**MOOLARBEN COAL COMPLEX
OPEN CUT OPTIMISATION MODIFICATION**

RESPONSE TO SUBMISSIONS

MOOLARBEN COAL PROJECT STAGE 1
PROJECT APPROVAL (05_0117) [MOD 14]

MAY 2018
Project No. MCM-16-14
Document No. 00918376

Figure 3: Predicted 24-hour average PM₁₀ Concentrations for Sensitive Receptor Locations 9 and 40 in Year 2019 (unmitigated)

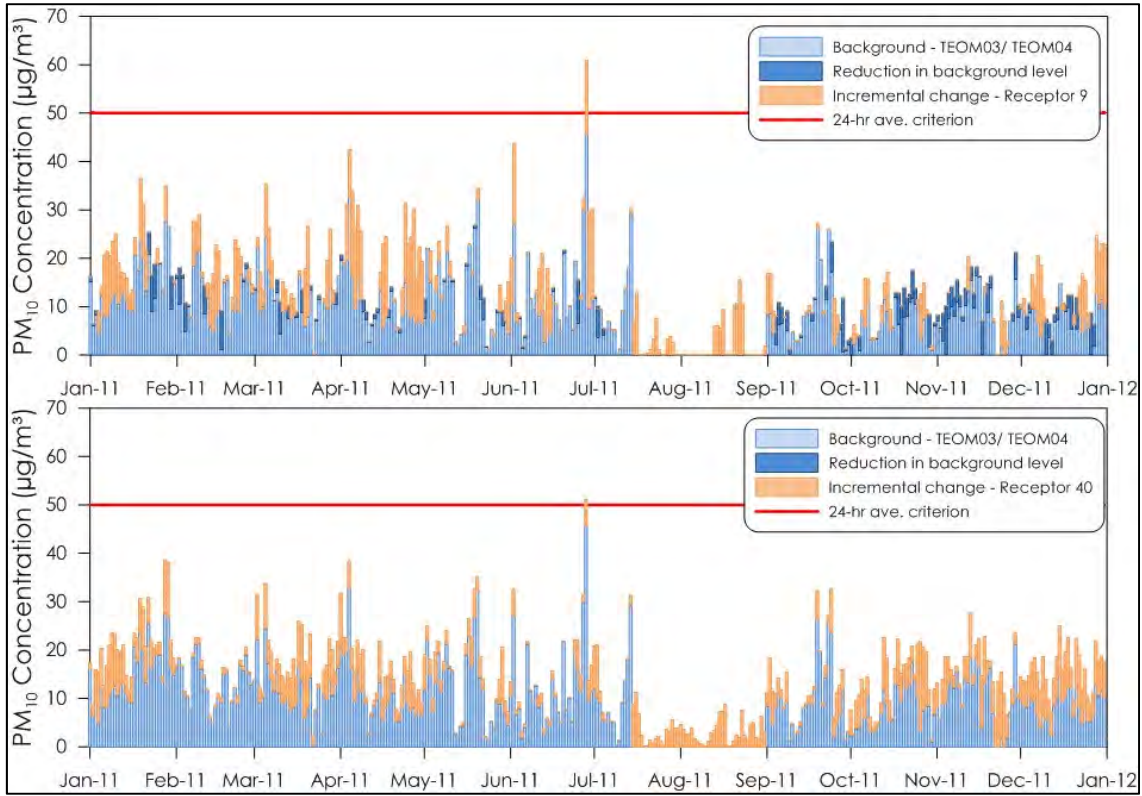
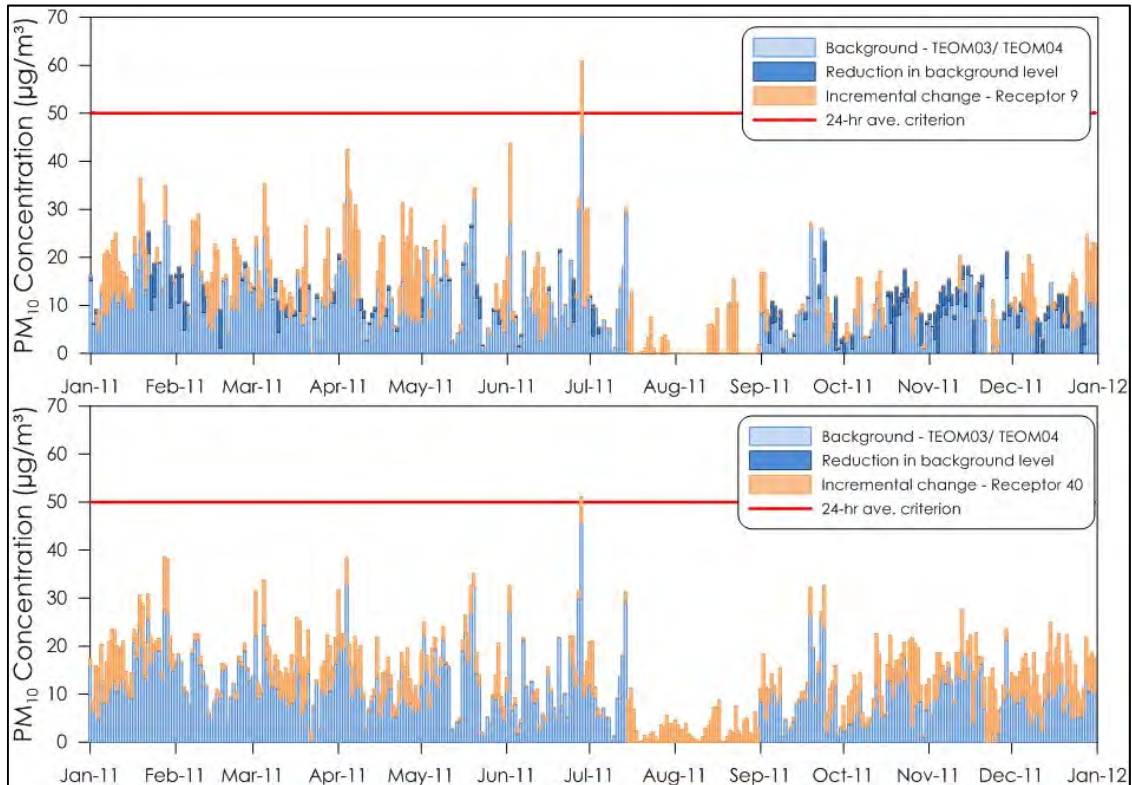
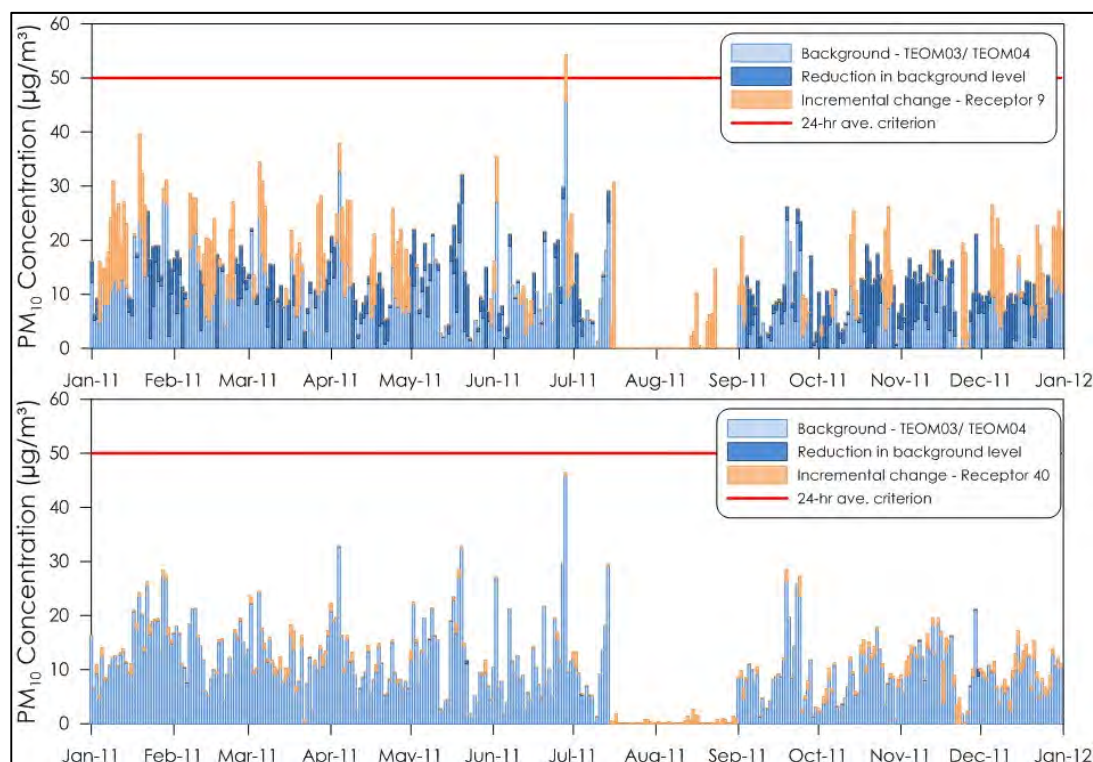
TAS (2017) does not provide information regarding the emissions inventory for the revised modelling.

For all other privately-owned receptors, it is predicted that without the implementation of real-time controls, the Moolarben Coal Complex including the Modification would result in up to an additional day per year above the 24-hour PM₁₀ criteria (when considered cumulatively with background sources).

Figures 7-8 to 7-10 from TAS (2017) (reproduced as Figures 3 to 5, below) show that for the most potentially impacted privately-owned receptor (Receptor 40), the predicted cumulative PM₁₀ concentration on the 1 additional day of exceedance is only marginally above the criterion of 50 µg/m³. On this basis, TAS (2017) concluded that the modelled exceedances could be avoided in practice with the implementation of the real-time controls currently implemented at the Moolarben Coal Complex.

Graph 4
Brine Generation and Storage

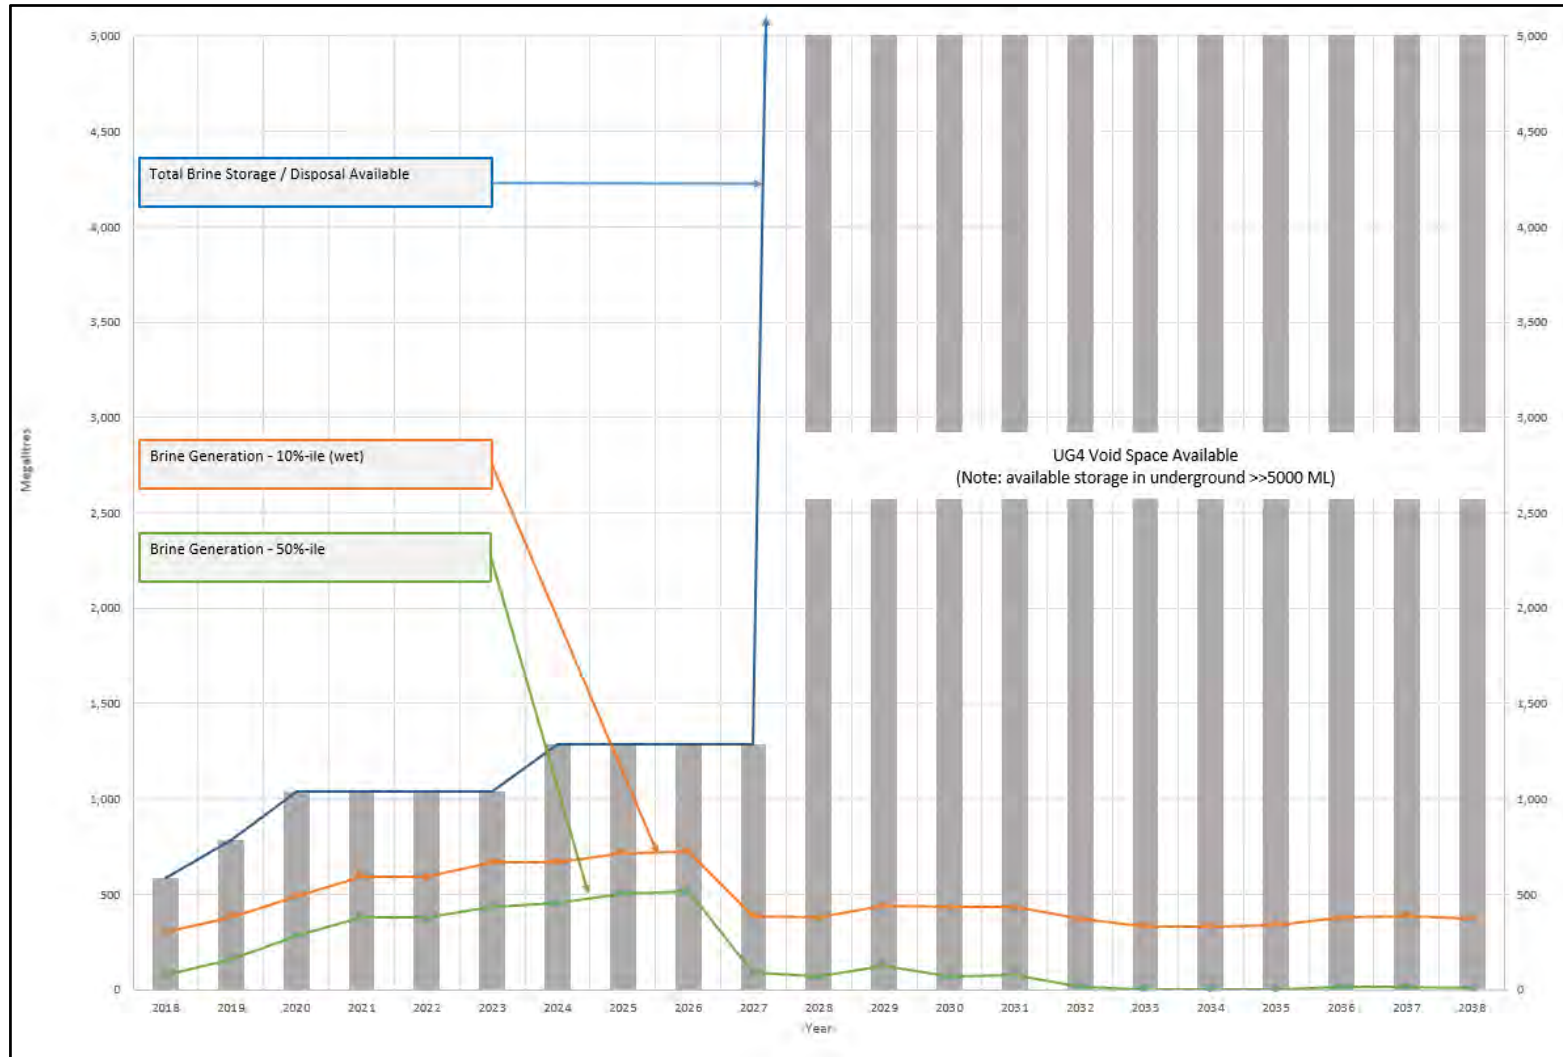
Page 52 of Appendix F provides discussion regarding assumptions made with regarding the water treatment plant and the likely volume of brine which will be produced. It is unclear to the EPA how brine has been accounted for in the site water balance.

Once void space is available in the underground workings (i.e. down gradient of longwall mining) brine generated from the treatment process would be permanently stored underground within the coal seam aquifer.

The estimated annual volume of brine generated under 10th percentile (wet) and 50th percentile climatic scenarios is shown on the Graph 4, below.

If brine accumulation during the period prior to permanent storage in the UG4 void exceeds the currently planned storage capacity, then additional temporary storage capacity will be constructed as required. For example, additional storages would be constructed in approved disturbance areas associated with open pits. Any additional temporary storages would be constructed consistent with existing mine water dams.
